UNITED STATES PATENT AND TRADEMARK OFFICE

CONFIRMATION NO. ATTORNEY DOCKET NO. FIRST NAMED INVENTOR FILING DATE APPLICATION NO. 1314 9903-40 Hyung-Jik Byun 01/16/2002 10/053,278 7590 07/02/2003 EXAMINER MARGER JOHNSON & McCOLLOM, P.C. STONER, KILEY SHAWN 1030 S.W. Morrison Street Portland, OR 97205 ART UNIT PAPER NUMBER

*		_	An
		Application No.	Applicant(s)	
	·	10/053,278	BYUN ET AL.	
	Office Action Summary	Examiner	Art Unit	
		Kiley Stoner	1725	
	- The MAILING DATE of this communication ap	pears on the cover st	neet with the correspondence ad	dress
eriod for	r Reply			
THE N - Extens after S - If the p - If NO - Failure - Any re earner	DRTENED STATUTORY PERIOD FOR REPL MAILING DATE OF THIS COMMUNICATION. sions of time may be available under the provisions of 37 CFR 1. SIX (6) MONTHS from the mailing date of this communication. period for reply specified above is less than thirty (30) days, a reppend for reply is specified above, the maximum statutory period e to reply within the set or extended period for reply will, by statut apply received by the Office later than three months after the mailing digital patent term adjustment. See 37 CFR 1.704(b).	136(a). In no event, however

FIG. 1

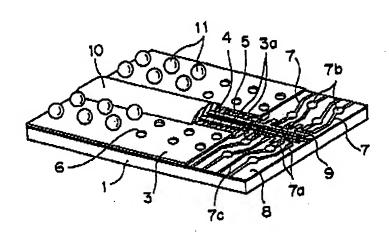
Amagai et al. teaches an enhanced pad having one or more pads coupled to one or more patterns (Figures 1 and 3; and column 4, line 36-column 5, line 2); said enhanced pads are formed near an outer edge of said substrate (Figures 1 and 3; and column 5, lines 45-63) a solder ball formed on said ball pad (Figures 1 and 3; and column 5, lines 45-63); a substrate, a plurality of enhanced pads each enhanced pad having one or more pads coupled to one or more patterns, a semiconductor ship mounted on and electrically connected to the top surface of the substrate (Figures 1 and 3; and column 4, line 36-column 5, line 2); a molding resin for encapsulating said semiconductor chip (column 1, lines 36-50 and column 2, lines 22-47); ball pads are arranged in a substantially lattice shape on the bottom surface of the substrate (Figures 1 and 3); said enhanced pads comprise a second enhanced pad, and wherein the second enhanced pad comprises a ball pad, a pad, and a pattern connecting said ball pad to said dummy pad (Figures 1 and 3; and column 4, line 36-column 5, line 2); said enhanced pads comprise a third enhanced pad, and wherein the third enhanced pad comprises a plurality of pads and a pattern for connecting said pads to each other (Figures 1 and 3; and column 4, line 36-column 5, line 2); said solder balls are all approximately the same size (Figures 1 and 3; and column 4, line 36-column 5, line 2); arranging ball pads on a bottom surface of the substrate (Figures 1 and 3; and column 4, line 36-column 5, line 2); arranging a plurality of enhanced pads on the bottom surface of the substrate, said enhanced pads comprising at least one pad coupled to at least one pattern (Figures 1 and 3; and column 4, line 36-column 5, line 2); arranging said enhanced pads further comprises arranging said enhanced pads near sides of the

substrate; one or more of said enhanced pads comprise a plurality of patterns (Figures 1 and 3; and column 4, line 36-column 5, line 2).

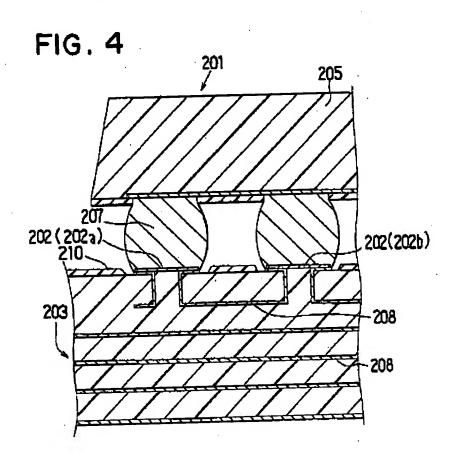
Kondo et al. teaches an enhanced pad having one or more pads coupled to one or more patterns (Figure 4, specifically "202a, 202b and 208"; column 4, lines 27-32; and column 6, lines 52-64); said enhanced pads are formed near an outer edge of said substrate (Figure 5); a solder ball formed on said ball pad (abstract and Figures); a substrate, a plurality of enhanced pads each enhanced pad having one or more pads coupled to one or more patterns, a semiconductor ship mounted on and electrically connected to the top surface of the substrate (Figure 4, specifically "202a, 202b and 208"; column 4, lines 27-32; and column 6, lines 52-64); a molding resin for encapsulating said semiconductor chip (column 4, lines 9-18); ball pads are arranged in a substantially lattice shape on the bottom surface of the substrate (Figures 1 and 3); said enhanced pads comprise a second enhanced pad, and wherein the second enhanced pad comprises a ball pad, a pad, and a pattern connecting said ball pad to said dummy pad (Figure 2; Figure 4, specifically "202a, 202b and 208"; column 4, lines 27-32; and column 6, lines 52-64); said enhanced pads comprise a third enhanced pad, and wherein the third enhanced pad comprises a plurality of pads and a pattern for connecting said pads to each other (Figure 2; Figure 4, specifically "202a, 202b and

208"; column 4, lines 27-32; and column 6, lines 52-64); a board, said board comprising enhanced lands corresponding to said enhanced pads and ball lands corresponding to said ball pads, wherein said semiconductor chip package is mounted on said board (Figure 2; Figure 4, specifically "202a, 202b and 208"; column 4, lines 27-32; and column 6, lines 52-64); said solder balls are all approximately the same size (Figures); a majority of said dummy patterns are arranged parallel to a long side of said substrate (Figure 4, specifically "202a, 202b and 208"); arranging ball pads on a bottom surface of the substrate (Figure 2; Figure 4, specifically "202a, 202b and 208"; column 4, lines 27-32; and column 6, lines 52-64); arranging a plurality of enhanced pads on the bottom surface of the substrate, said enhanced pads comprising at least one pad coupled to at least one pattern (Figure 2; Figure 4, specifically "202a, 202b and 208"; column 4, lines 27-32; and column 6, lines 52-64); arranging said enhanced pads further comprises arranging said enhanced pads near sides of the substrate; one or more of said enhanced pads comprise a plurality of patterns (figure 2; Figure 4, specifically "202a, 202b and 208"; column 4, lines 27-32; and column 6, lines 52-64).

FIG. 7

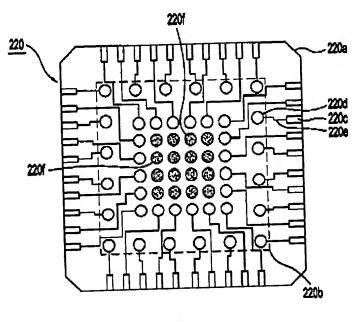
Hsu et al. teaches an enhanced pad having one or more pads coupled to one or more patterns (Figure 7, specifically "220c, 220d, 220e"; column 3, lines 14-column 4, line 44); said enhanced pads are formed near an outer edge of said substrate (Figure 5); a solder ball formed on said ball pad (abstract and Figures); a substrate, a plurality of enhanced pads each enhanced pad having one or more pads coupled to one or more patterns, a semiconductor ship mounted on and electrically connected to the top surface of the substrate (Figure 7, specifically "220c, 220d, 220e"; column 3, lines 14-column 4, line 44); a molding resin for encapsulating said semiconductor chip (column 1, lines 12-33 and column 3, lines 15-20); ball pads are arranged in a substantially lattice shape on the bottom surface of the substrate (Figure 7); said enhanced pads comprise a second enhanced pad, and wherein the second enhanced pad comprises a ball pad, a pad, and a pattern connecting said ball pad to said dummy pad (Figure 7, specifically "220c, 220d, 220e"; column 3, lines 14-column 4, line 44); said enhanced pads comprise a third enhanced pad, and wherein the third enhanced pad comprises a plurality of pads and a pattern for connecting said pads to each other (Figure 7, specifically "220c, 220d, 220e"; column 3, lines 14-column 4, line 44); a board, said board comprising enhanced lands corresponding to said enhanced pads and ball lands corresponding to said ball pads, wherein said semiconductor chip package is mounted on said board (Figure 7, specifically "220c, 220d, 220e"; column 3, lines 14-column 4, line 44); said solder balls are all approximately the same size (Figures); a majority of said dummy patterns are

arranged parallel to a long side of said substrate (Figure 7, specifically "220c, 220d, 220e"; column 3, lines 14-column 4, line 44); arranging ball pads on a bottom surface of the substrate (Figure 7, specifically "220c, 220d, 220e"; column 3, lines 14-column 4, line 44); arranging a plurality of enhanced pads on the bottom surface of the substrate, said enhanced pads comprising at least one pad coupled to at least one pattern (Figure 7, specifically "220c, 220d, 220e"; column 3, lines 14-column 4, line 44); arranging said enhanced pads further comprises arranging said enhanced pads near sides of the substrate; one or more of said enhanced pads comprise a plurality of patterns (Figure 7, specifically "220c, 220d, 220e"; column 3, lines 14-column 4, line 44).
